Reservoir Embankment changes & inclusion of an offshore valve tower

Planning references: HBC APP/24/00311

Havant Thicket Reservoir: Application for Reserved Matters relating to Phase 3 – Main Embankment; Changes in relation to siting, scale, external appearance and landscaping of the reservoir embankments, pursuant to condition 2. New layout is based on the revised Section 73 application layout, which includes the offshore valve tower.

Section 73 application to vary Conditions 2 (pre commencement condition) & 3 (approved plans) for proposed changes to the size & alignment of the main reservoir embankment and related infrastructure including; a new offshore valve tower, changes to the Avenue Staircase & western viewpoint

G8. Proposed Culvert & Valve Tower Layout Drg.0013

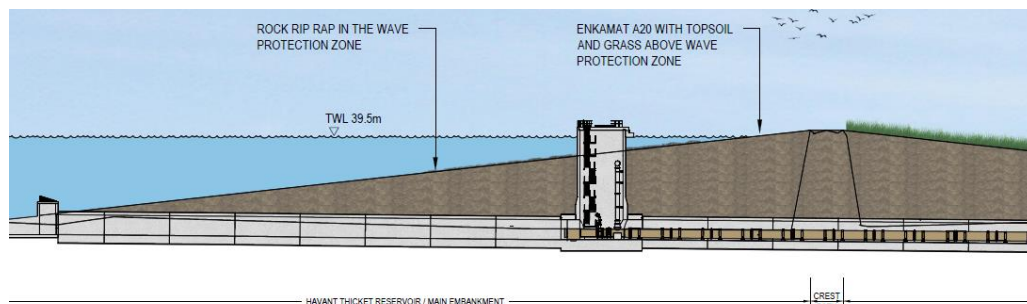
It is clear from Drawing 0013 that there is only a small gap between the crane platform extending north from the crest road (but not labelled), to the valve tower. Concerns about public safety and visibility could be addressed by infilling the gap to create a promontory that would ensure that the valve tower is not located in an offshore position.
